MONITORING YEAR 5 ANNUAL REPORT

HENRY FORK MITIGATION SITE

RE: **Response to MY5 Draft Report Comments**
Henry Fork Mitigation Project
DMS Project # 96306
Contract Number 005782
RFP Number 16-005298
Catawba River Basin – CU# 03050103 Expanded Service Area
Catawba County, North Carolina

Monitoring Year 5 - 2020

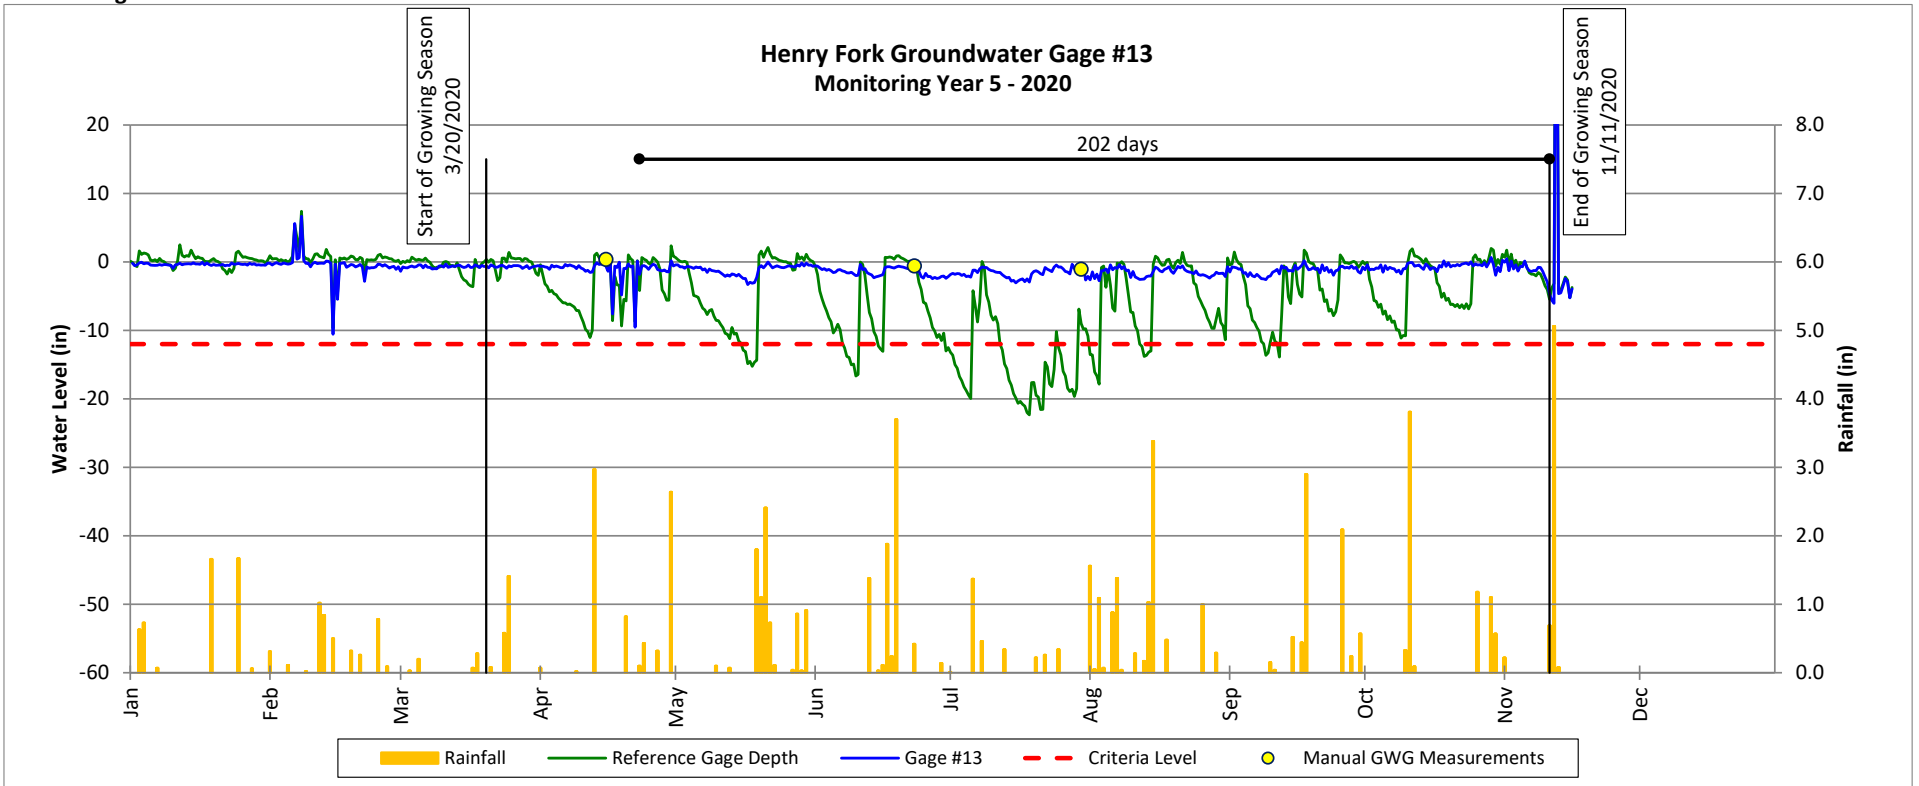
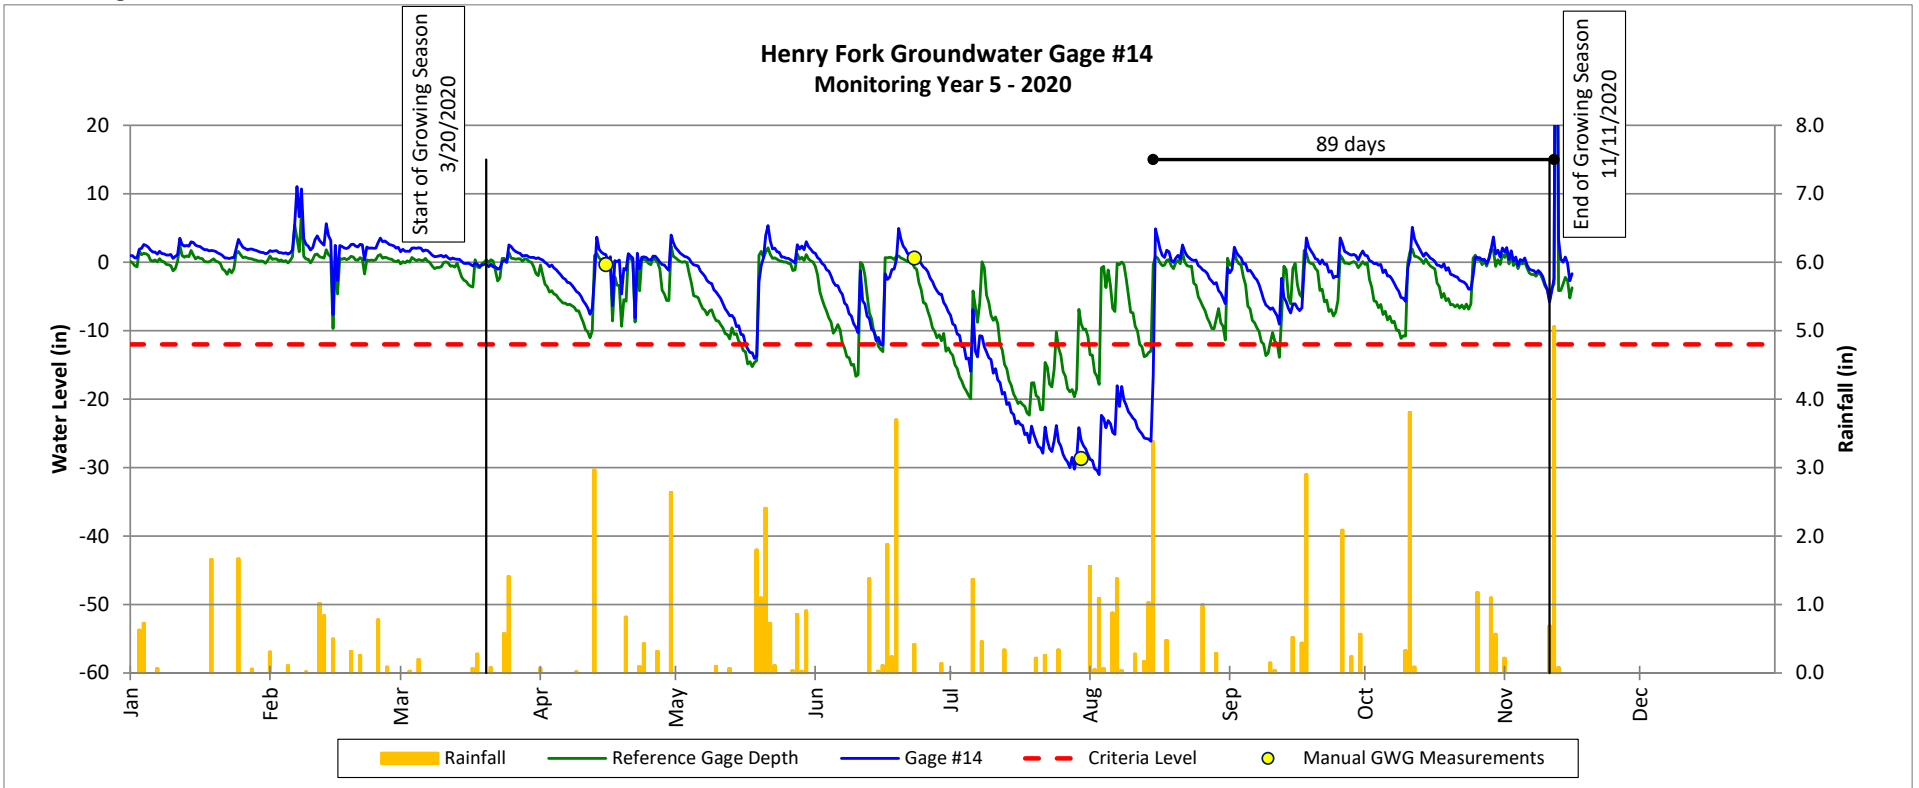
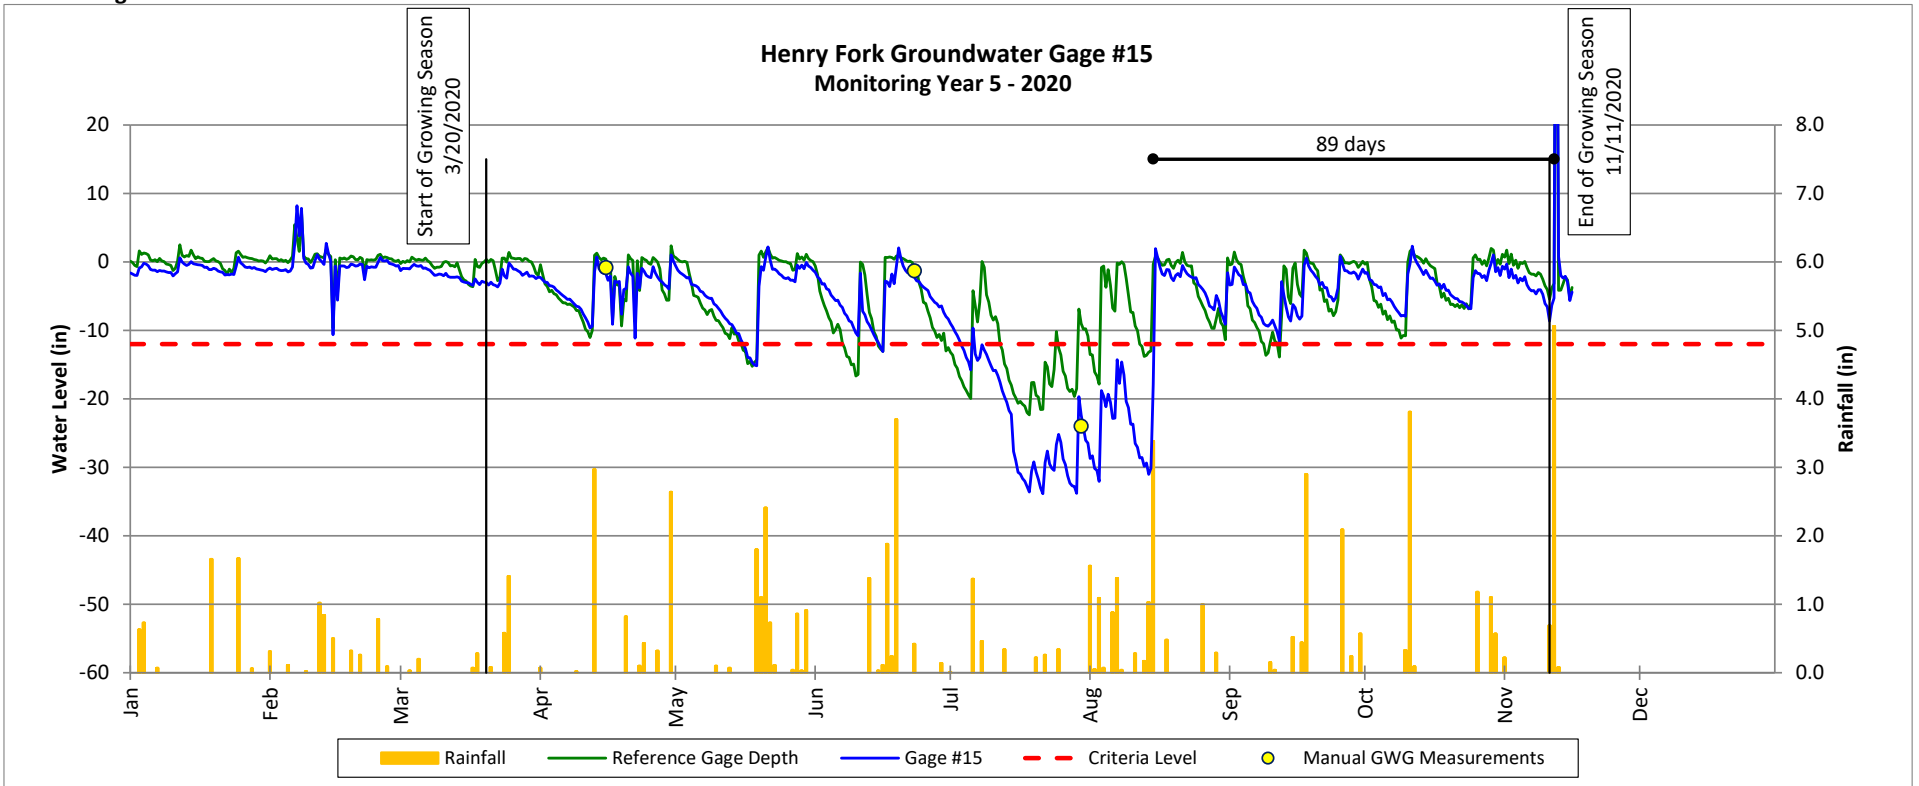
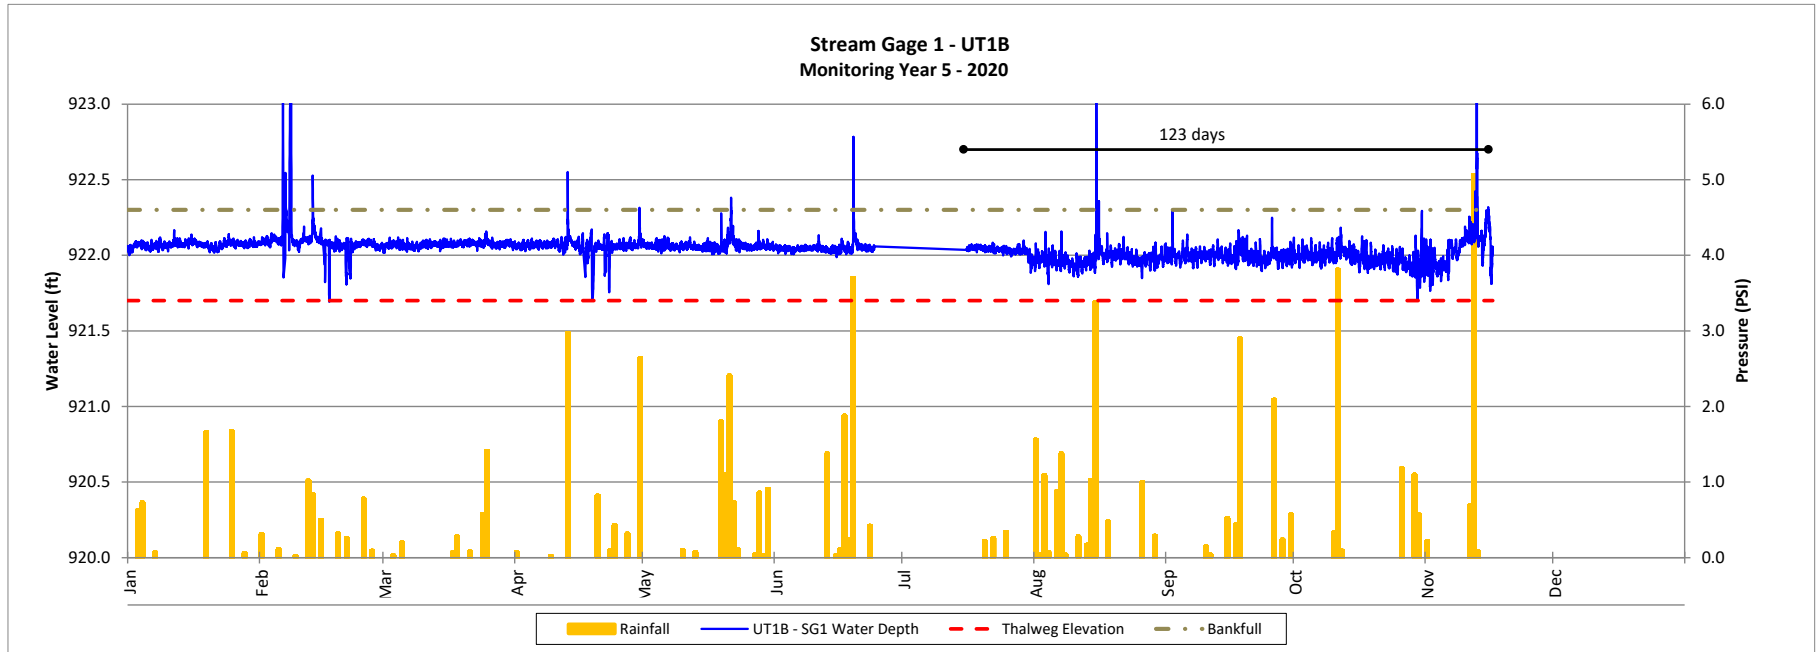
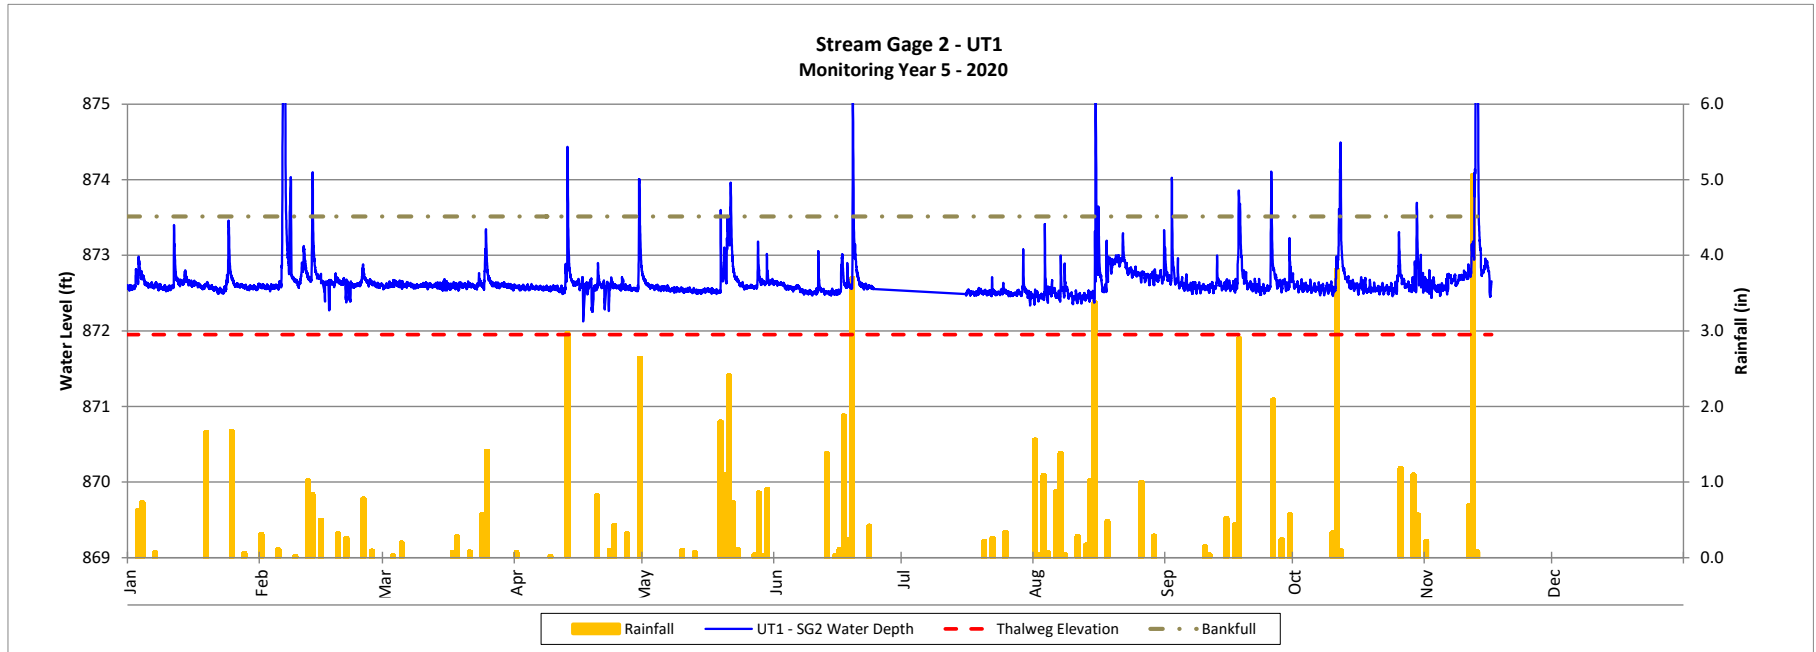
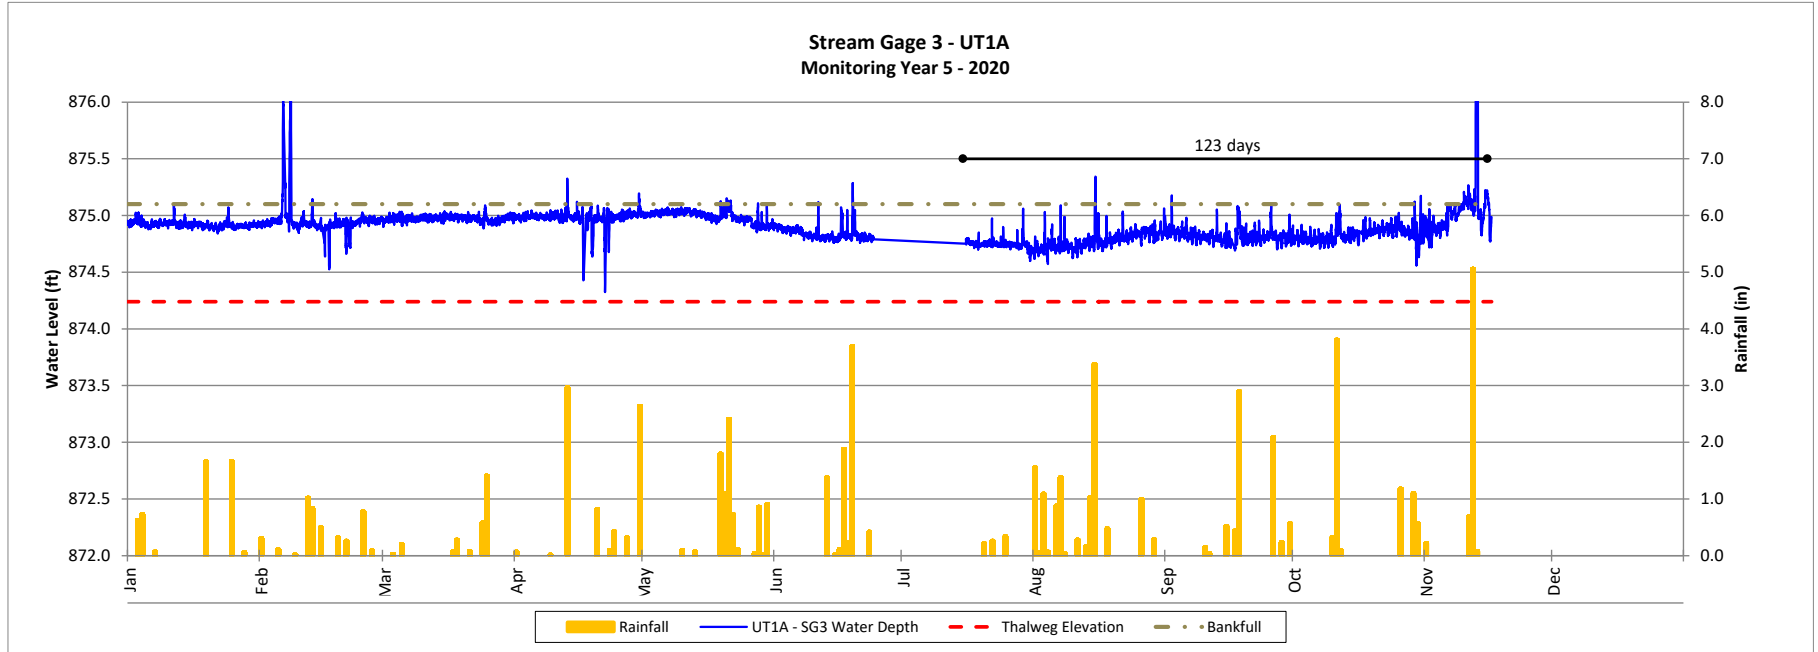
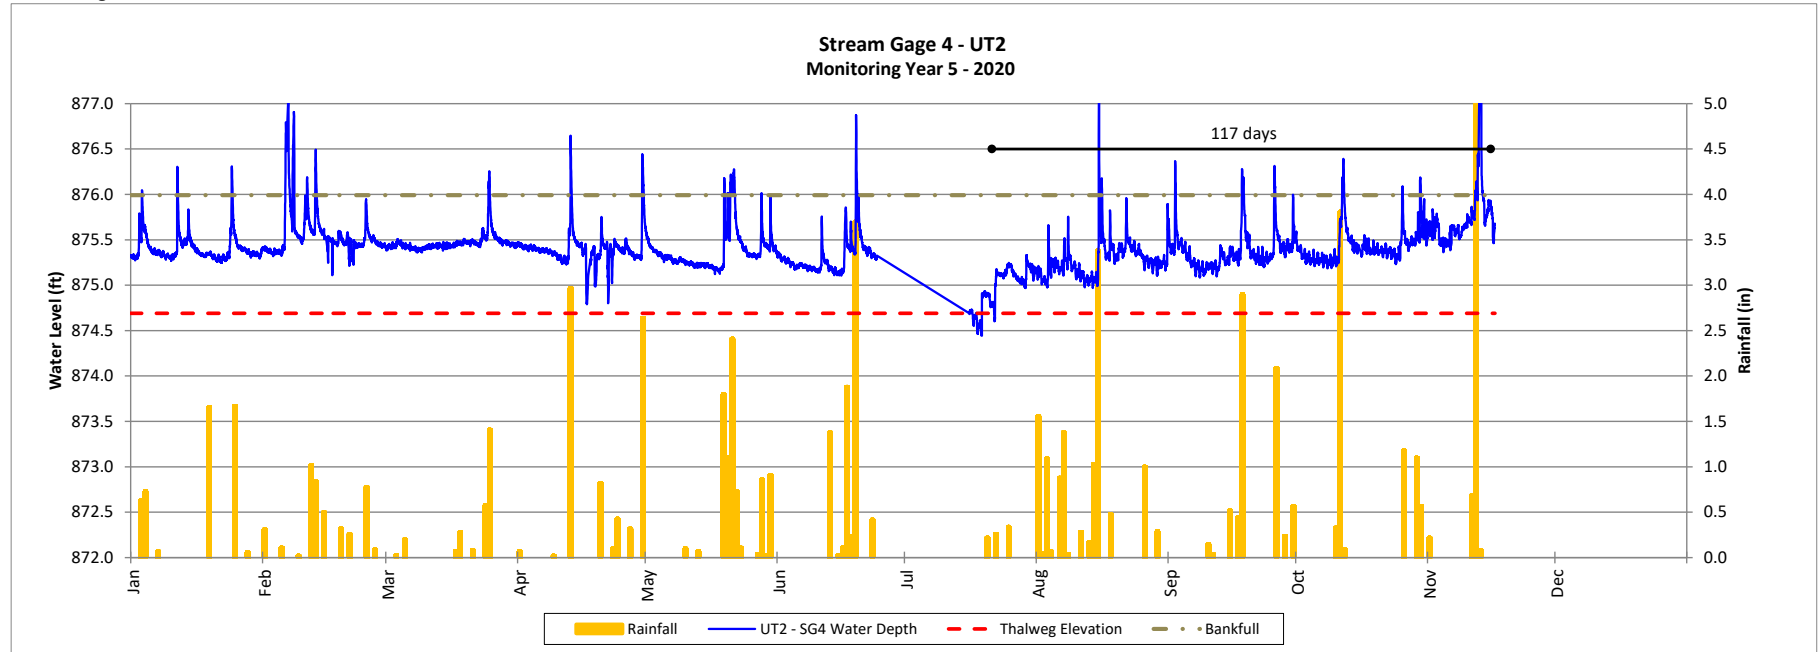
DMS comment: Groundwater Gage Plots: The note at the bottom of the graphs regarding the barotroll malfunction is unclear. It says the data collected during the February and April 16-17 malfunctions were omitted, but then then says the readings conducted during April 16-22 was verified and included. Is the April 16 date in the verified statement supposed to be April 21? Please review and revise as necessary.

Wildlands response: The note at the bottom of the groundwater gage plots has been revised and simplified to indicate that the data collected during the February and April malfunctions was omitted from the reported data.
